ADDENDUM NO. 02
TO THE CONSTRUCTION DOCUMENTS BID PACKAGE

Client: Arrowhead Regional Medical Center
Project: Oncology-Ambulatory Clinic
SHA Project No.: 18242.100
Date: September 12, 2019

ARROWHEAD REGIONAL MEDICAL CENTER M.O.B. ONCOLOGY-AMBULATORY CLINIC

M125

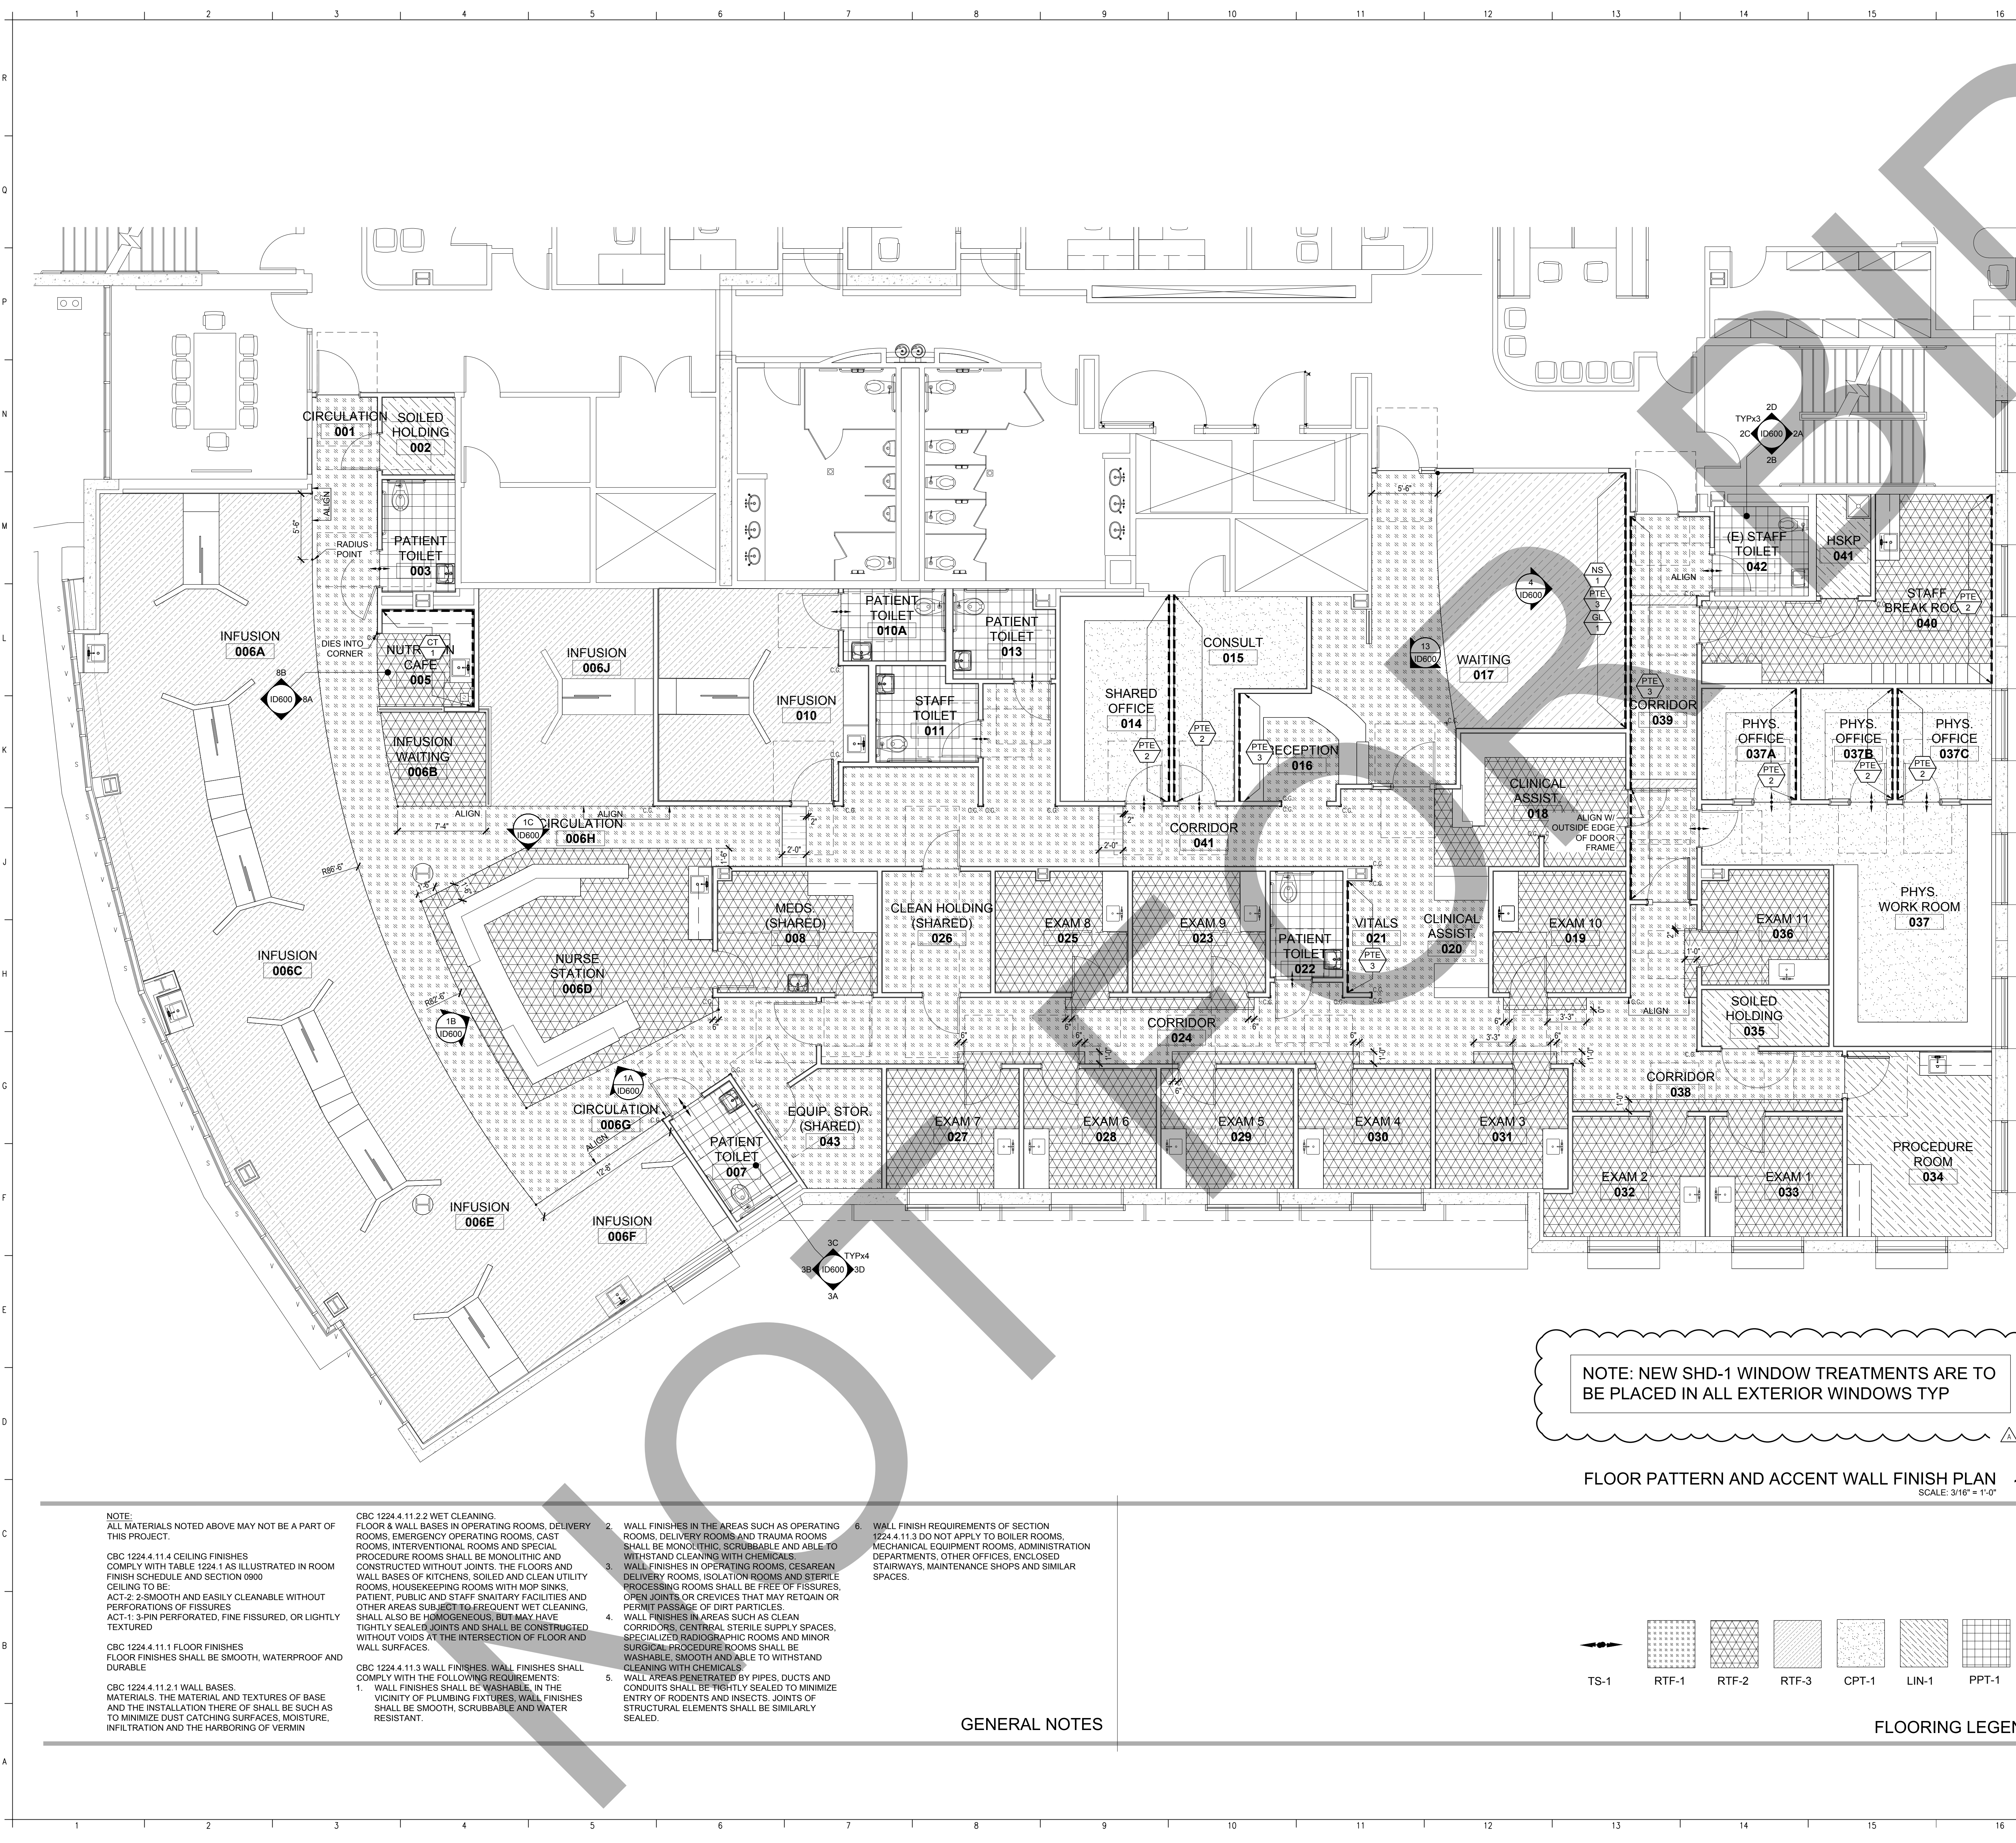
- A605** Revised detail number.
- M111** Revised demolition scope in the existing public restrooms.
- M122** Revised ductwork.
- M125** Added note to sheet regarding patching exterior finishes.
Added General Note #4 referencing framing details.

ID300

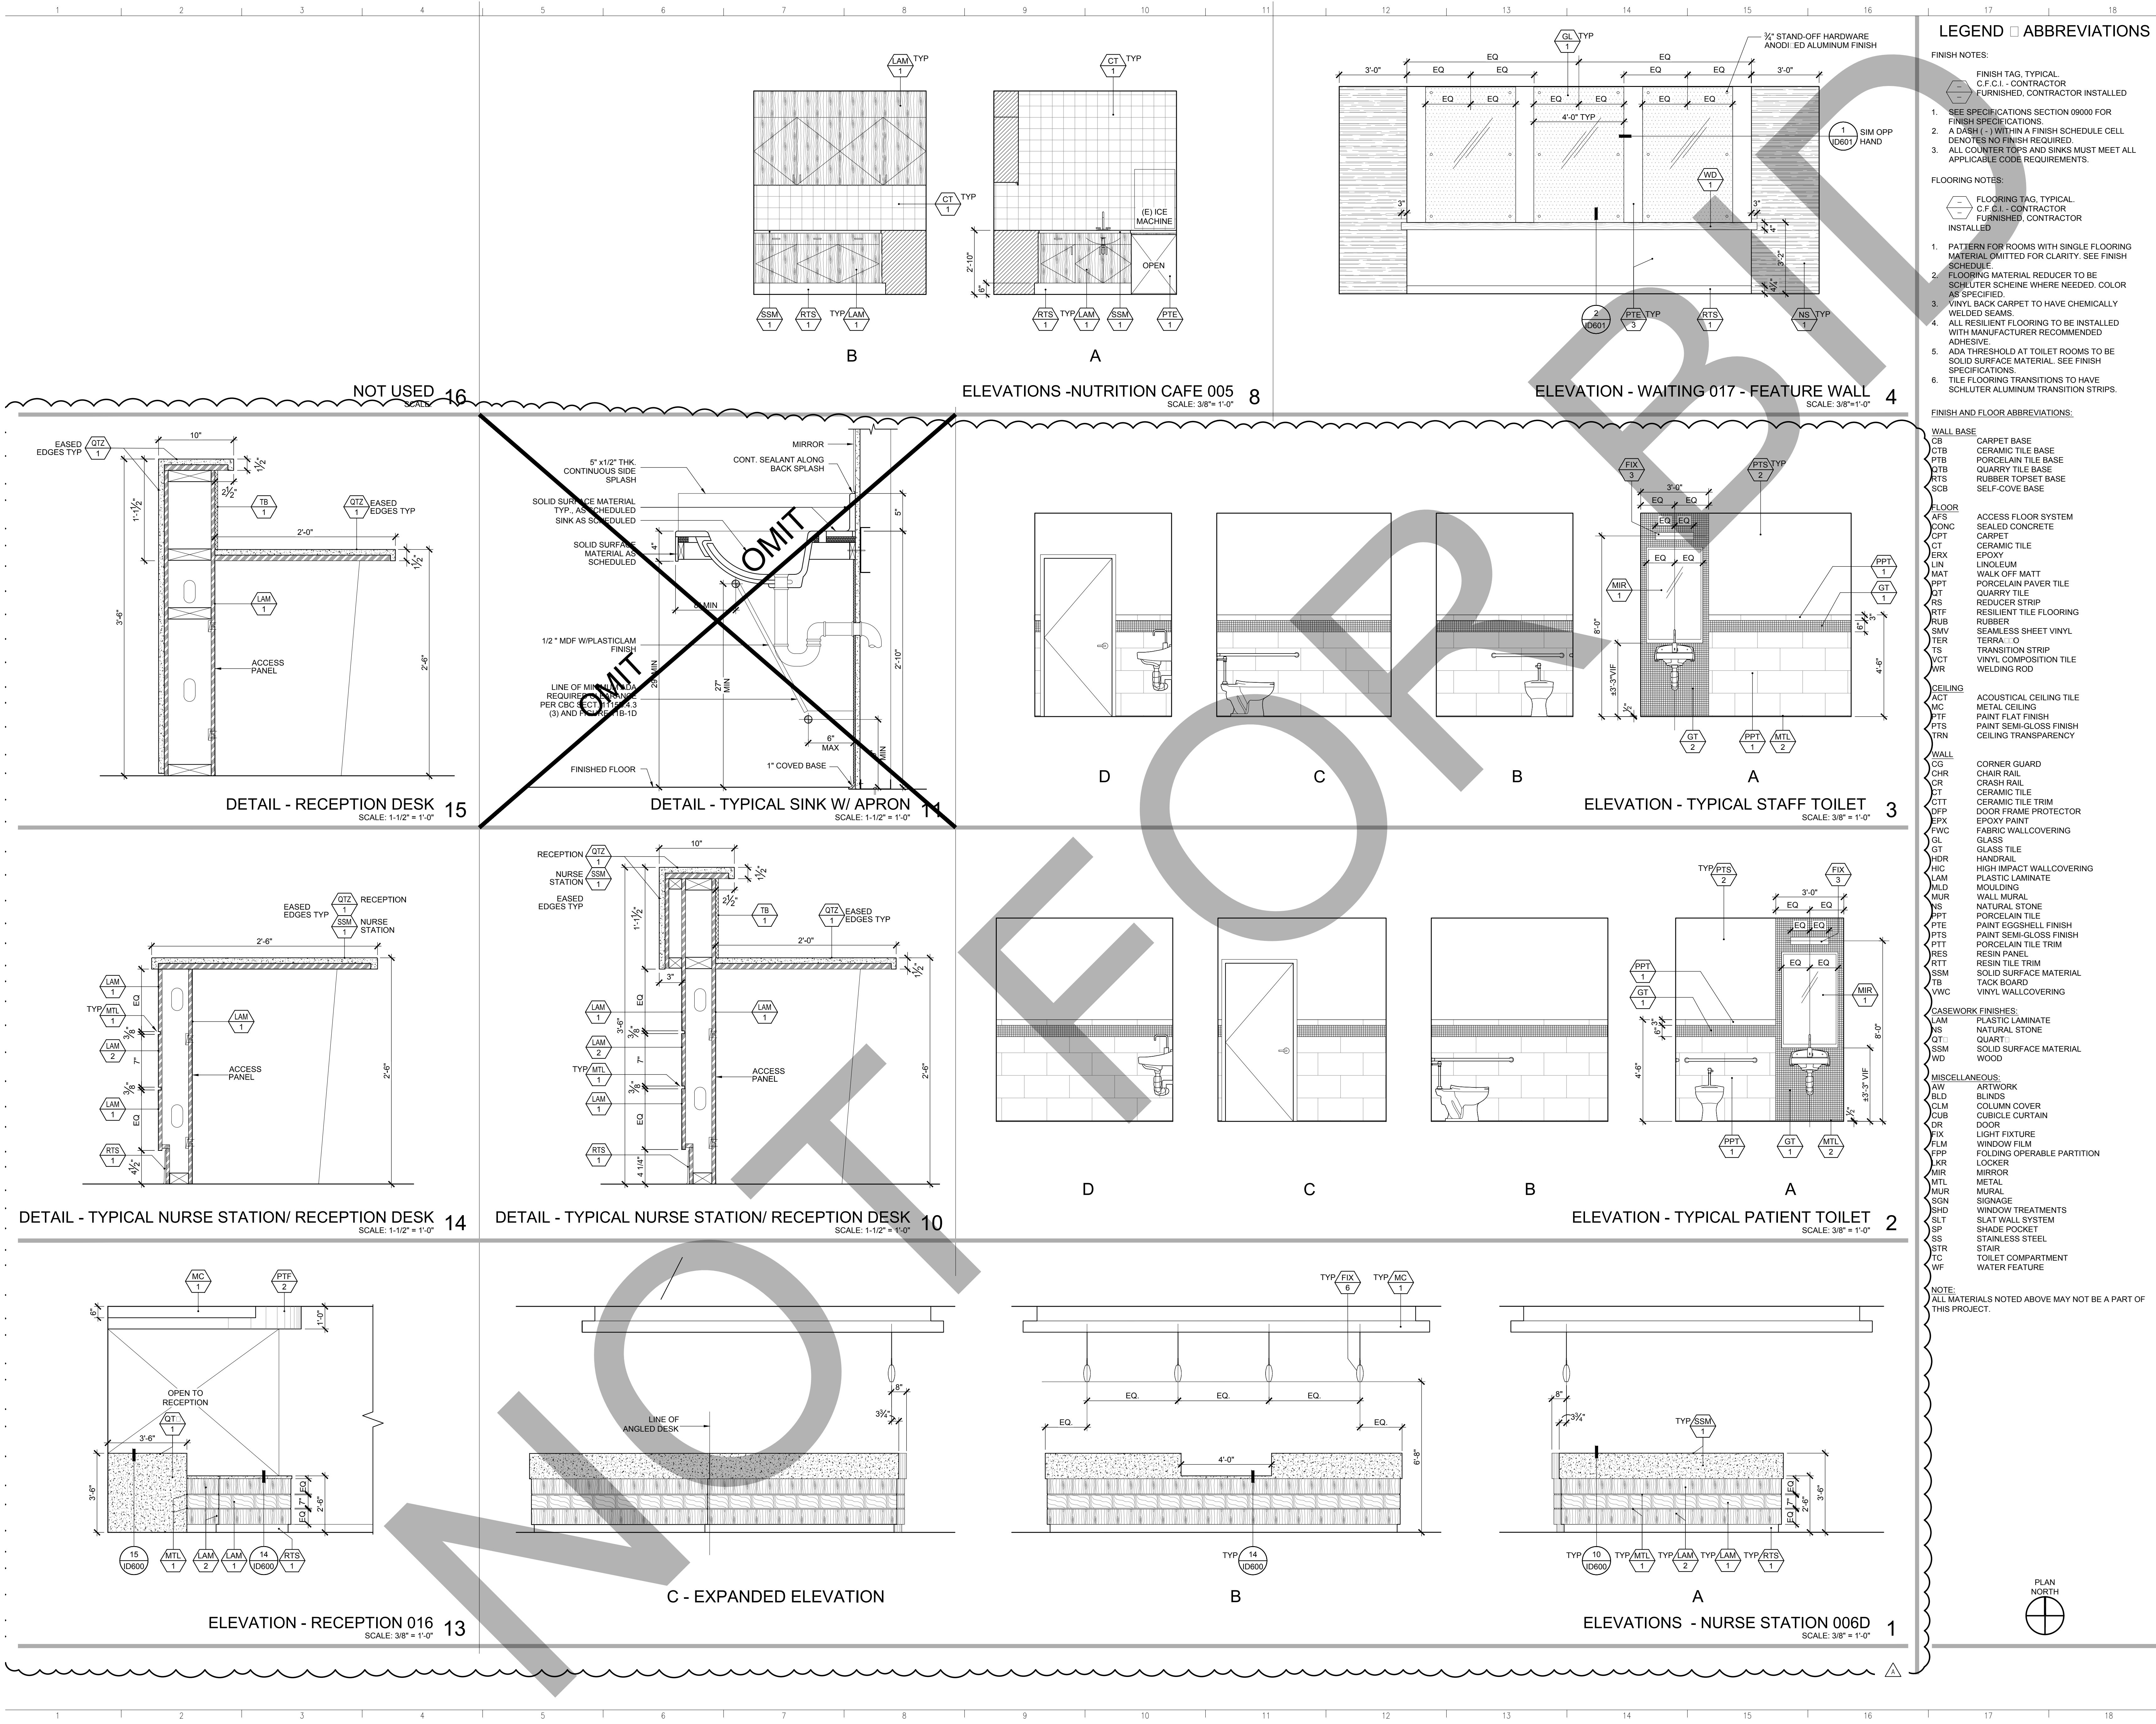
ID300 Added Note to plan regarding Window Treatments.

005.1	Please advise who is responsible for Window Treatment. Specification section 09 00 00 calls for Window Treatment SHD-1 to match building standards, but there are no call outs on the drawings.	Window Treatments are to be contractor furnished/contractor installed. See revised Interior Design drawings and Specification Sections attached.

NOTE: NEW SHD-1 WINDOW TREATMENTS ARE TO BE PLACED IN ALL EXTERIOR WINDOWS TYP
